UNECE EVS-IWG

OICA comments on EVS24-E1TP-0400
EVS #25 meeting
2022

Feedback on TF Toxicity questions

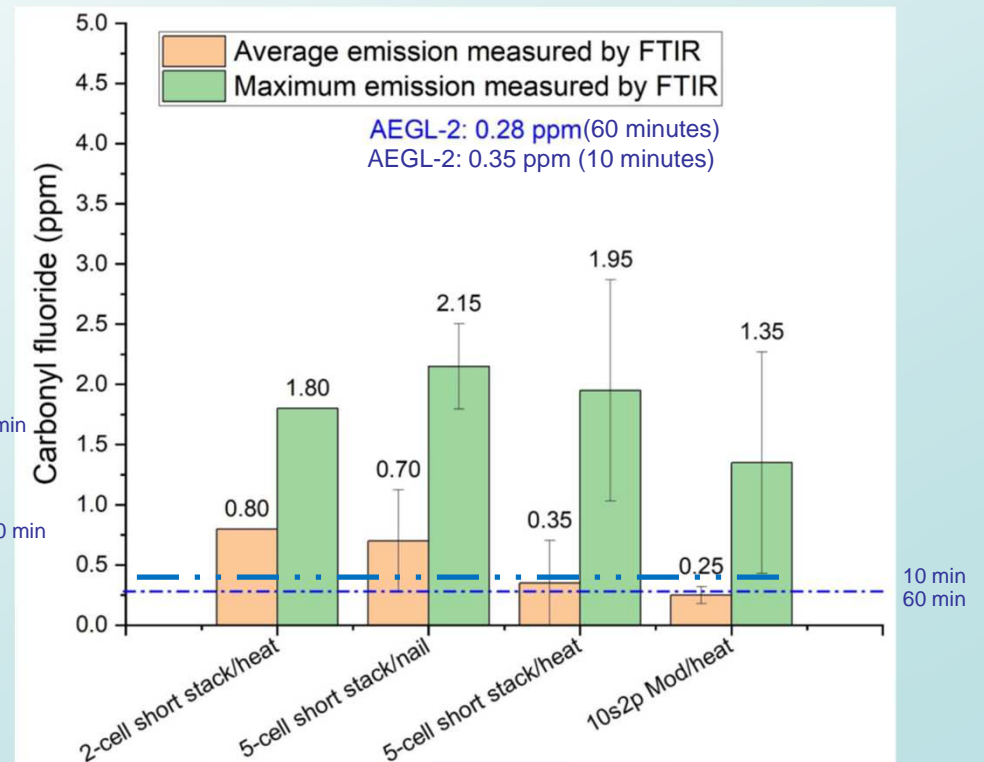
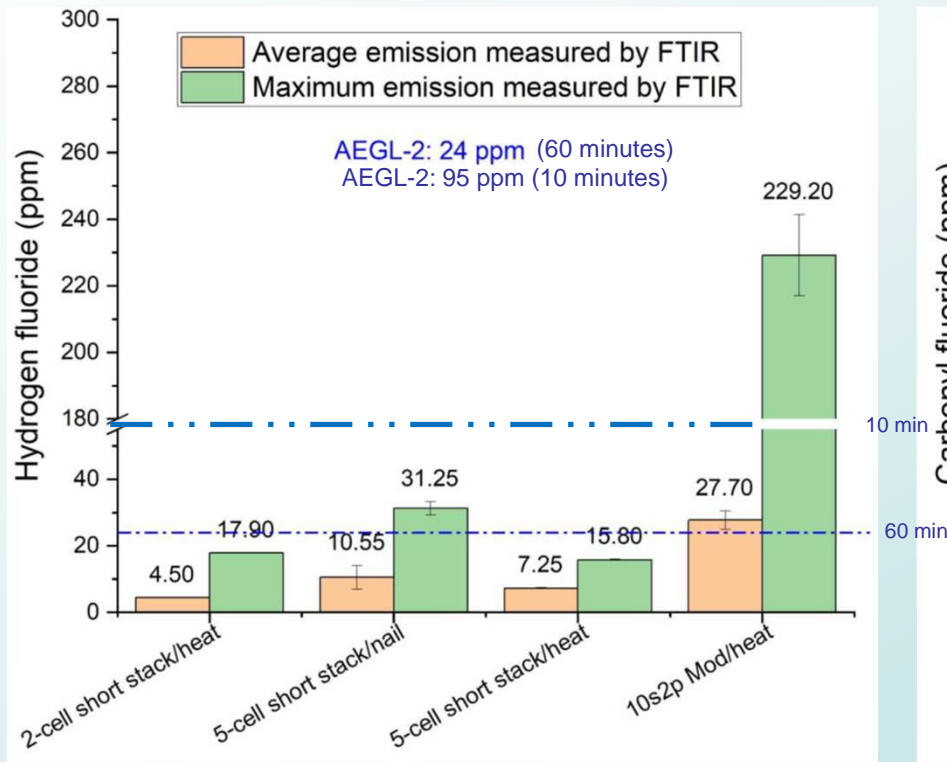
➤ AEGL-2 10 minutes criteria should be considered for the toxicity studies

➤ AEGL-2 10 minutes criteria should be considered for the toxicity studies

- Concerning acrolein emissions find in this test, please consider emissions from woodburning: 21-132 ppm, exposure time? (Table 6-2. Acrolein in Emissions from Combustion, Toxicological Profile for Acrolein, The Agency for Toxic Substances and Disease Registry (ATSDR), U.S. Department of Health and Human Services)
